COUNTY PROJECT NO. 049-283-015, SHEET NO. ...10... OF ...27... SHEETS

PLAN & PROFILE

PLAN & PROFILE
COUNTY PROJECT NO. 049-283-015 SHEET NO. 11 OF 27 SHEETS

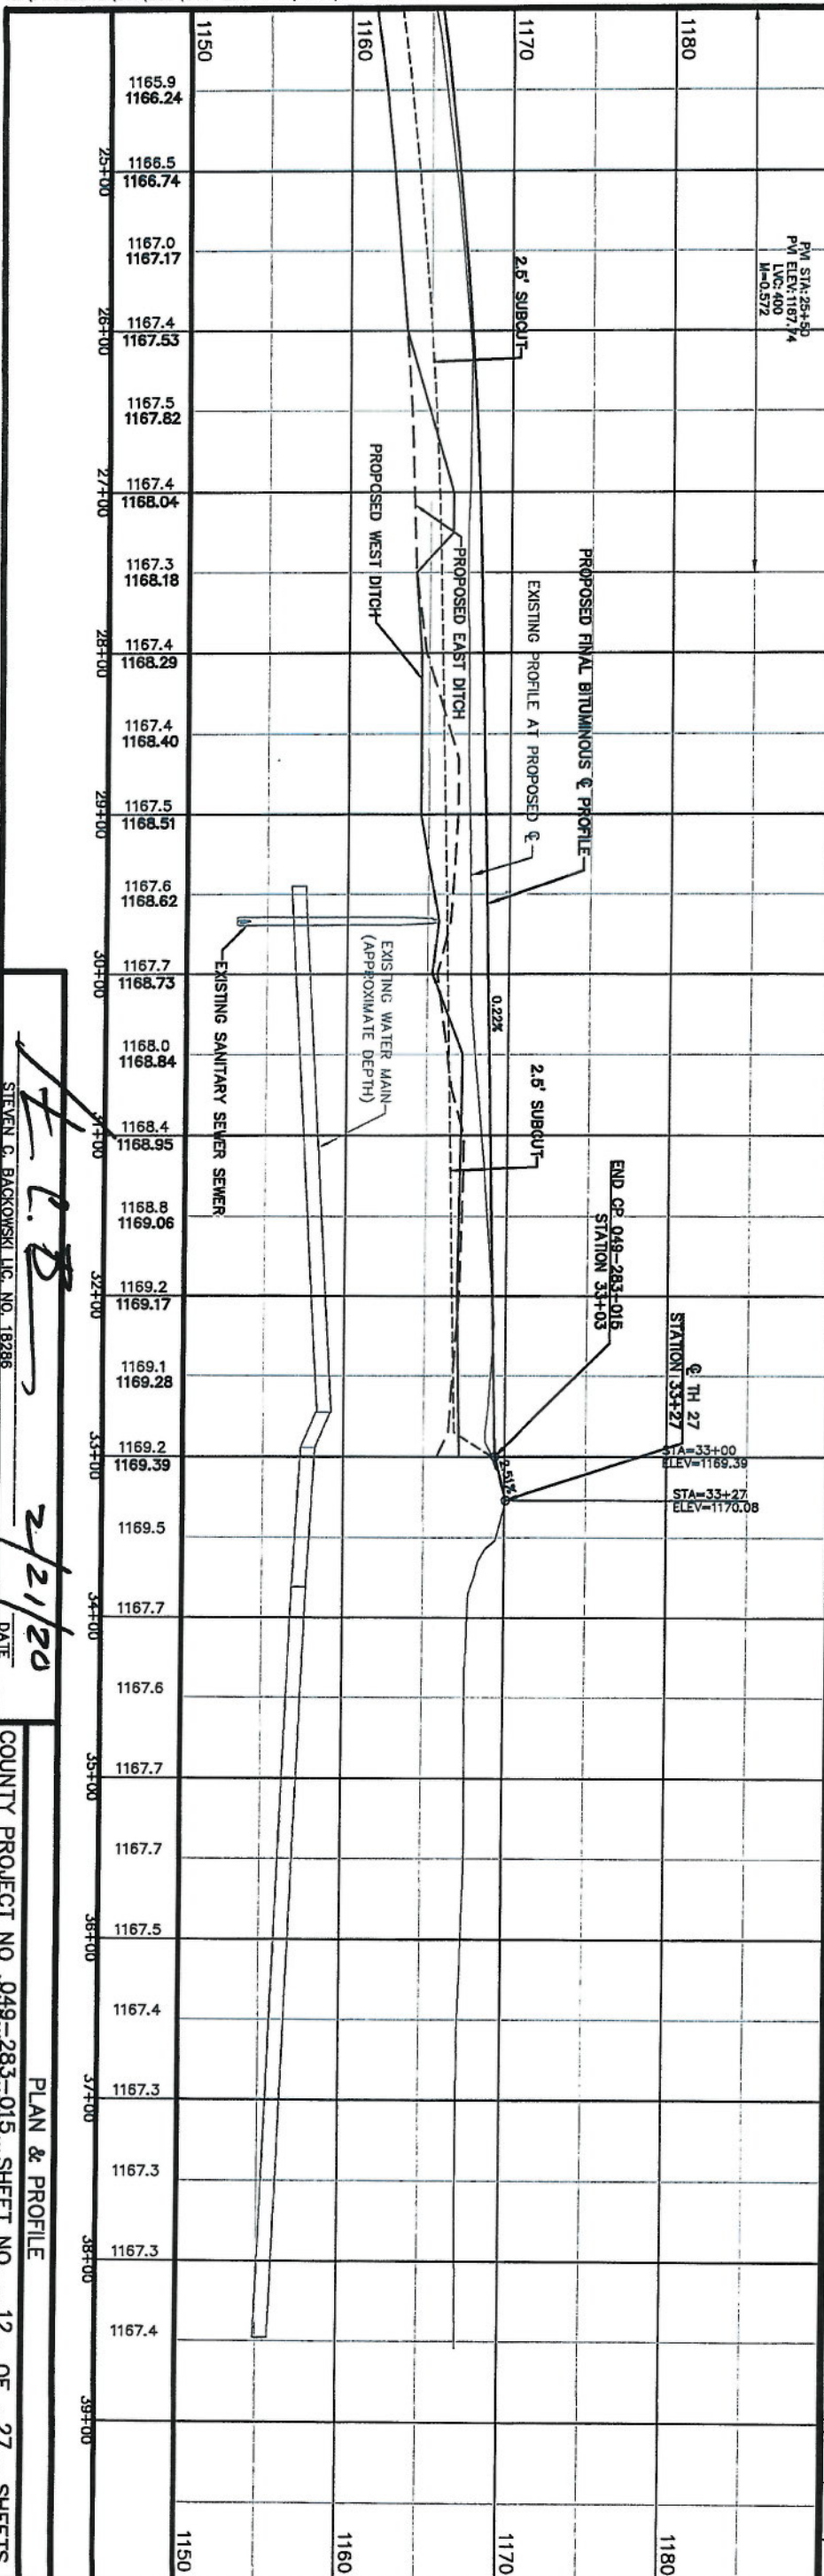
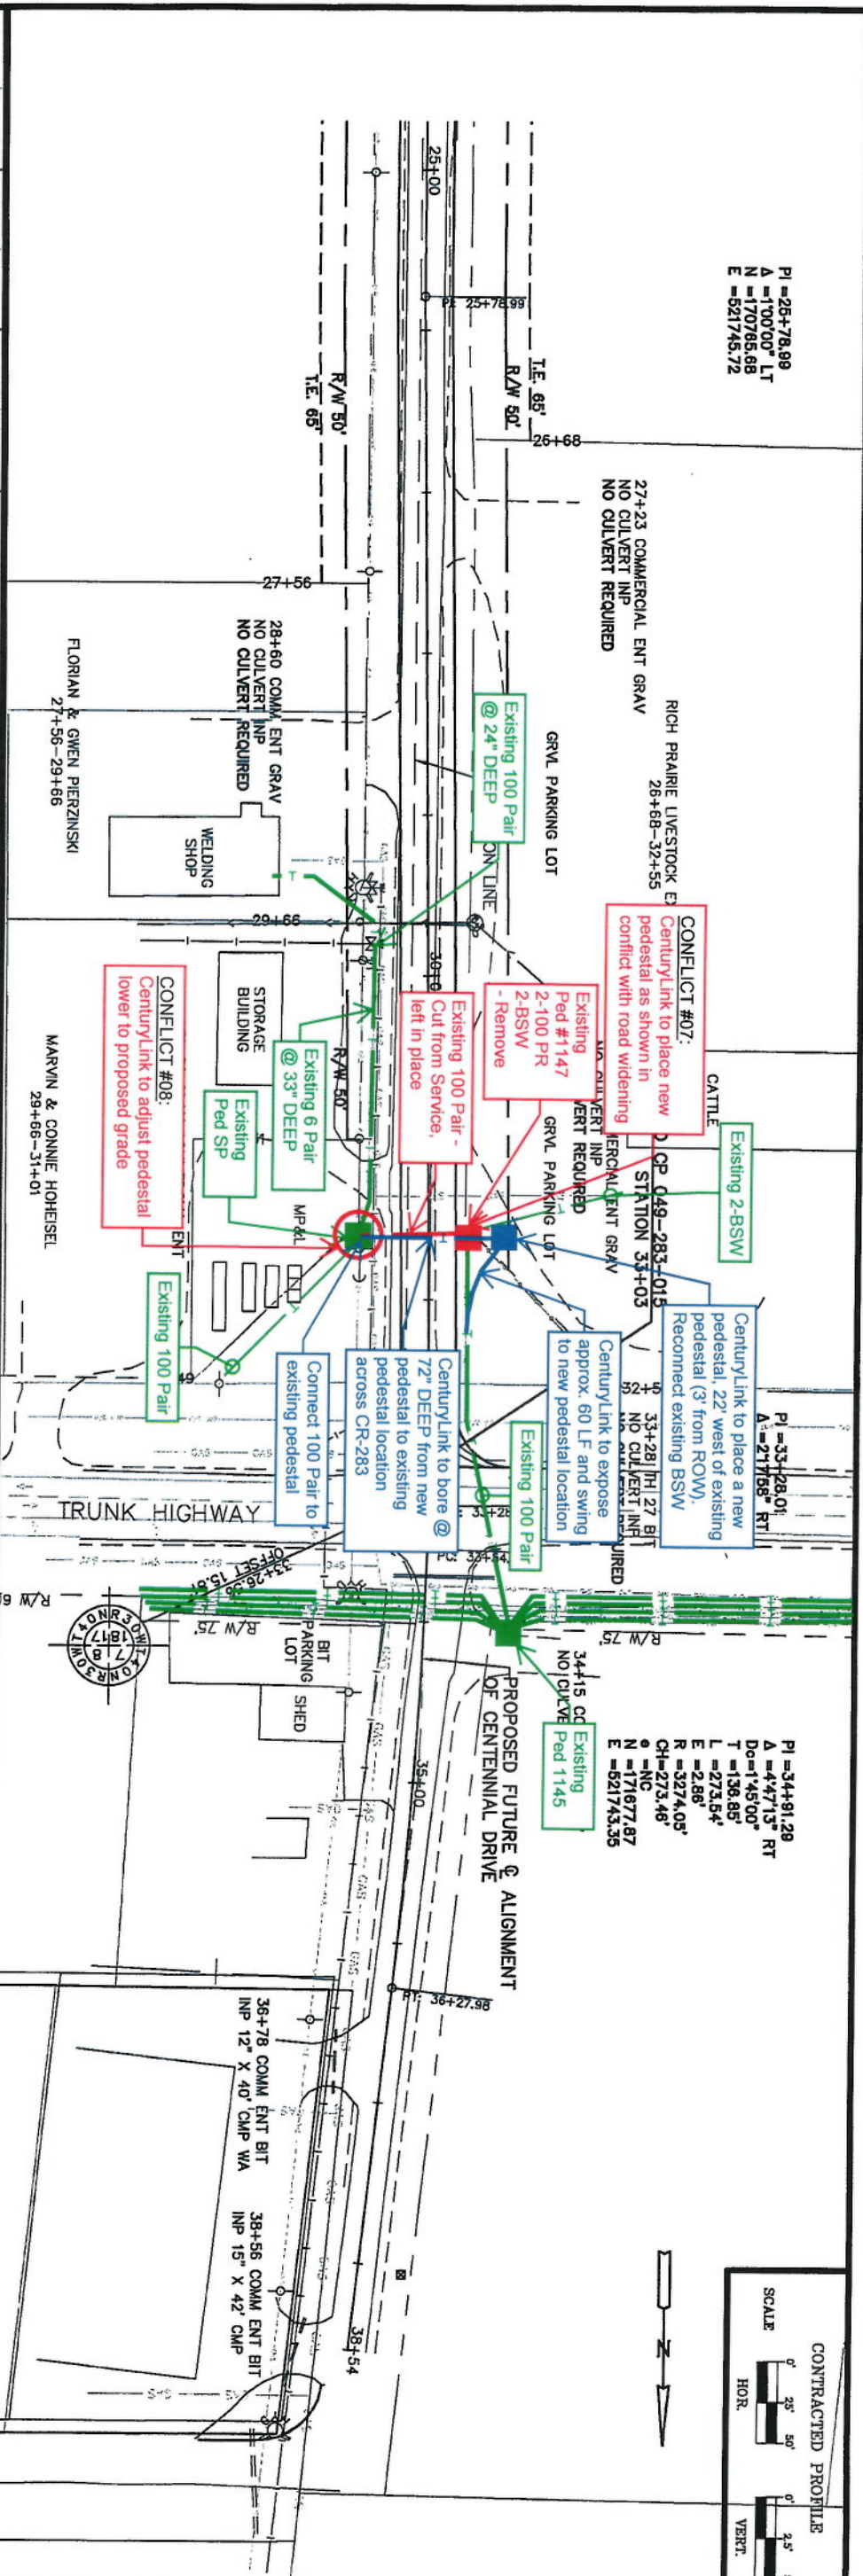
CONFLICT #07:
 CenturyLink to place new
 pedestal as shown in
 conflict with road widening

Existing 100 Pair
 @ 24" DEEP
 - Remove

Existing 100 Pair -
 Cut from Service,
 left in place

Existing 6 Pair
 @ 33" DEEP
 Existing Ped SP

CONFLICT #08:
 CenturyLink to adjust pedestal
 lower to proposed grade

Existing 100 Pair
 Connect 100 Pair to
 existing pedestal

CenturyLink to bore @
 72" DEEP from new
 pedestal to existing
 pedestal location
 across CR-283

CenturyLink to place a new
 pedestal, 22' west of existing
 pedestal (3' from ROW),
 Reconnect existing BSW

CenturyLink to expose
 approx. 60 LF and swing
 to new pedestal location
